1984 Corvette: Service Bulletin: Engine Stops Running When Starting with Air Conditioning "On"

Model and Year: 1984 Corvette with Automatic Transmissions

Bulletin No: 84-240

A/C CLUTCH ON REVISED ECM SIGNAL INPUT BLOCK DIAGRAM

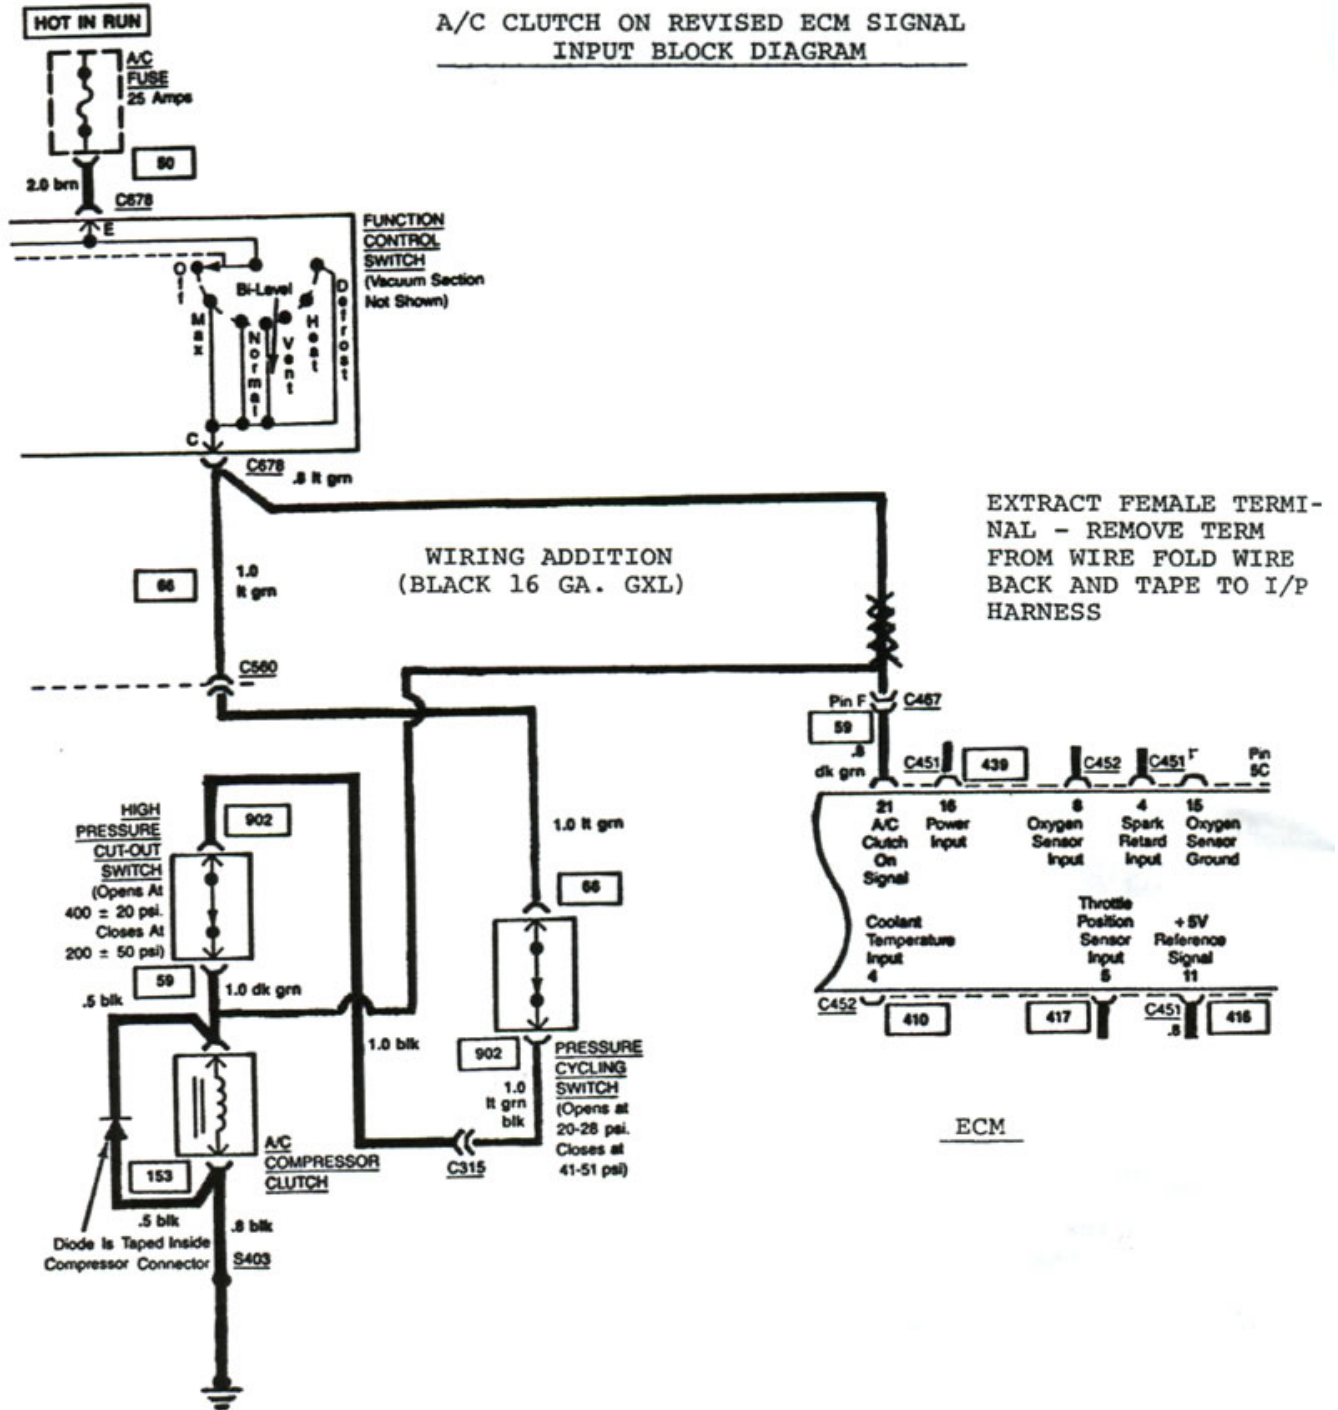
This revision requires installing a 16 Ga. wire into the A/C discrete circuit at connector C-467, Pin F of the I/P to ECM harness, routing the wire through the bulk head connector and splicing into the A/C circuit of the engine, between the pressure cycling switch and the compressor clutch (see block diagram).

FIGURE 1

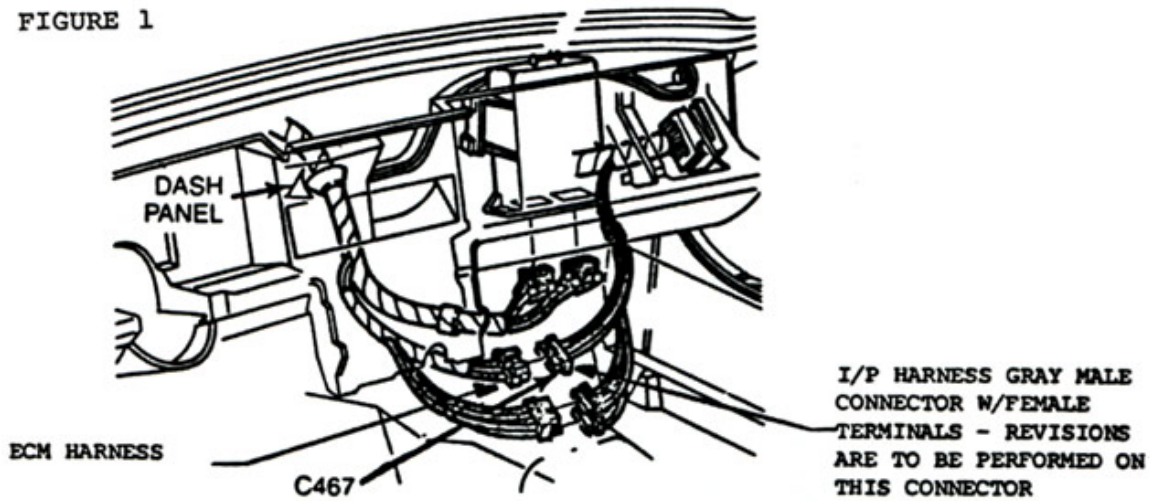
1. Remove I/P upper trim pad assembly. Remove L.H. and R.H. hush panels.
2. Extract female terminal (green wire) from gray I/P to ECM harness connector C-467, circuit 66 (see Figure 1.)
3. Cut off and discard extracted female terminal. Fold severed green wire back and tape it to the I/P harness, making sure the severed wire end is well insulated with electrical tape.
4. Utilize the 22 feet of 16 Ga. GXL black wire by stripping one end and crimping, P/N 12015856, female terminal on the stripped end. Insert the new terminal into connector C-467, Pin F.

FIGURE 3

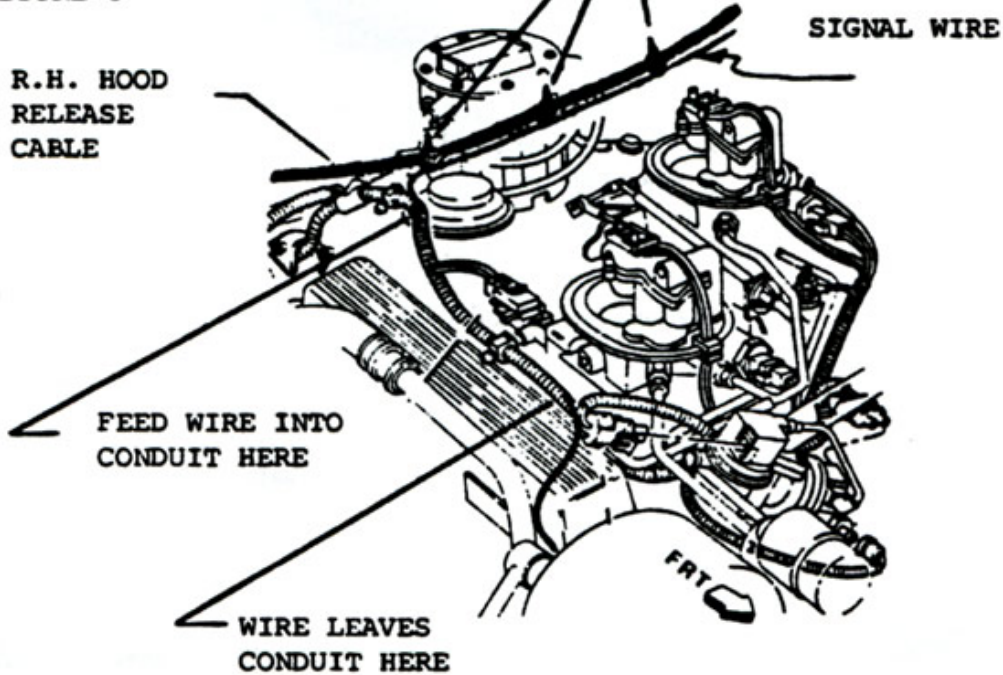
9. Once the signal wire has been fed through the bulk head connector, grease is to be packed around the signal wire at both sides of the connector. This step assures an adequate bulk head connector to signal wire seal.
10. Reinstall the bulk head harness caps.
11. Loop the signal wire down below the bulk head connector and back up behind the brake booster (see Figure 2.)
12. Route the signal wire along the R.H. hood release cable securing the wire to the cable with three (3) cable ties.
13. At the R.H. rear corner of the engine, direct the wire to the front of the engine and install it in the existing engine harness conduit (see Figure 3.)

FIGURE 4

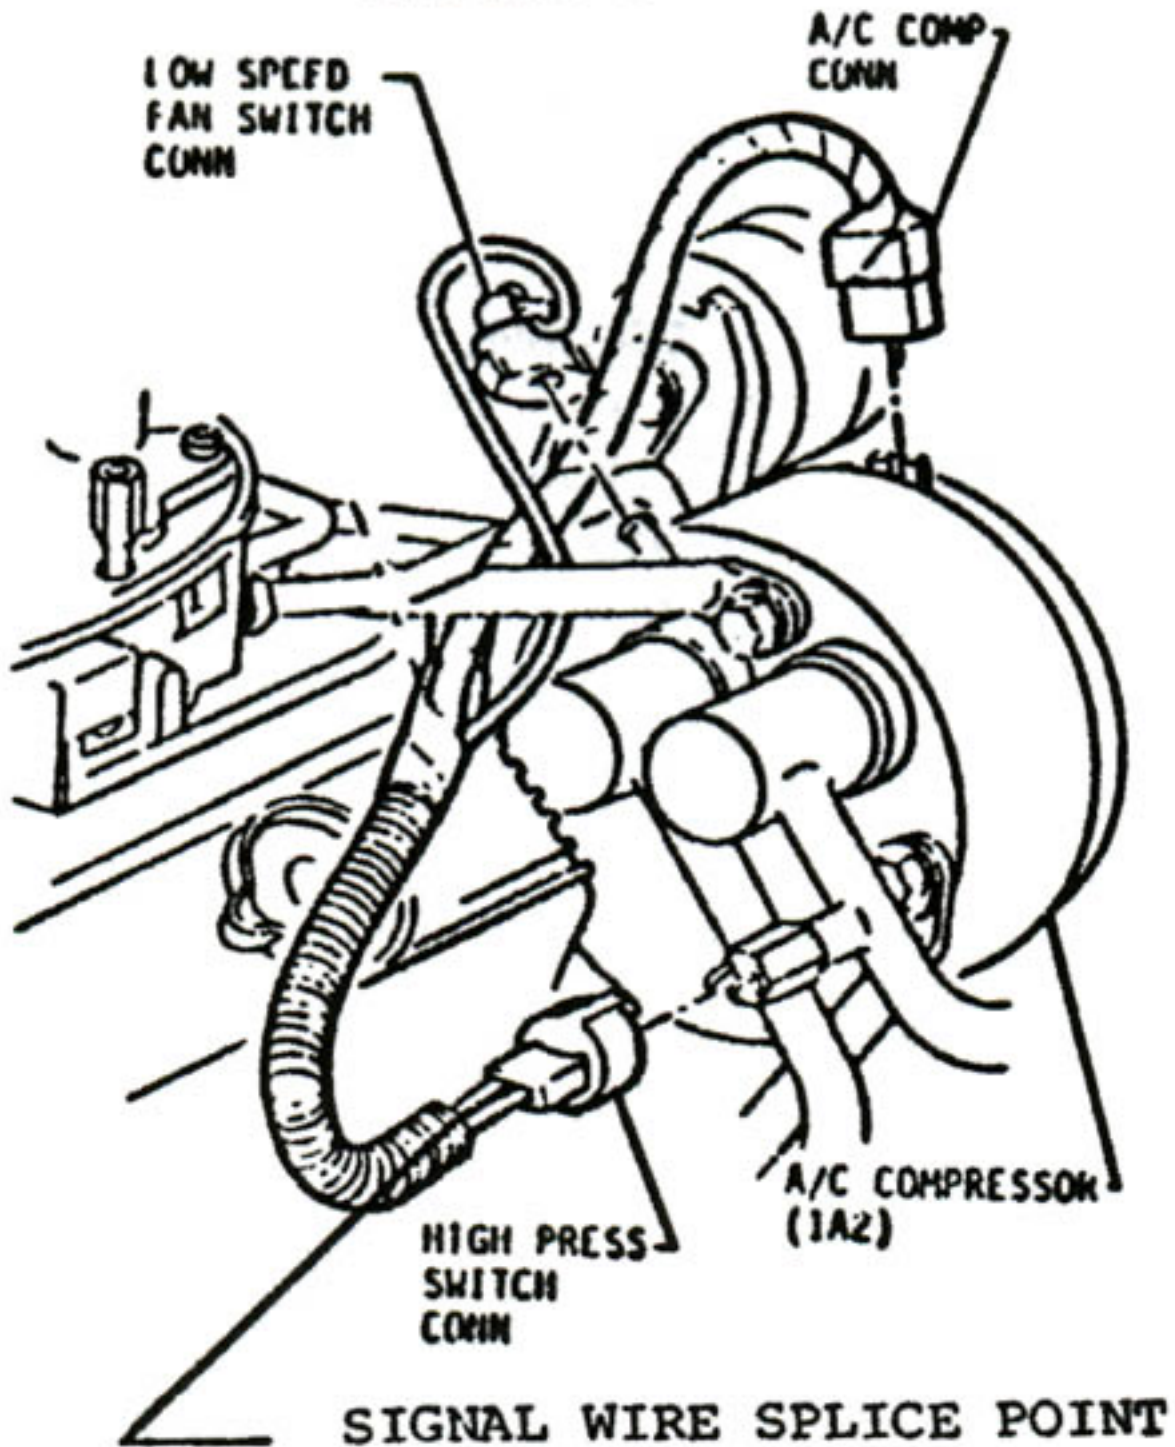
14. Remove the harness end tape and strip the insulation back .5 inches on the green wire at the high pressure A/C switch connector (see Figure 4.)
15. Remove excess signal wire length, if necessary, and strip end back .75 inches. Wrap the signal wire around the A/C clutch green wire and solder to insure a good connection.
16. Retape harness at high pressure switch connector.
17. Reinstall I/P upper trim panel and hush panels.
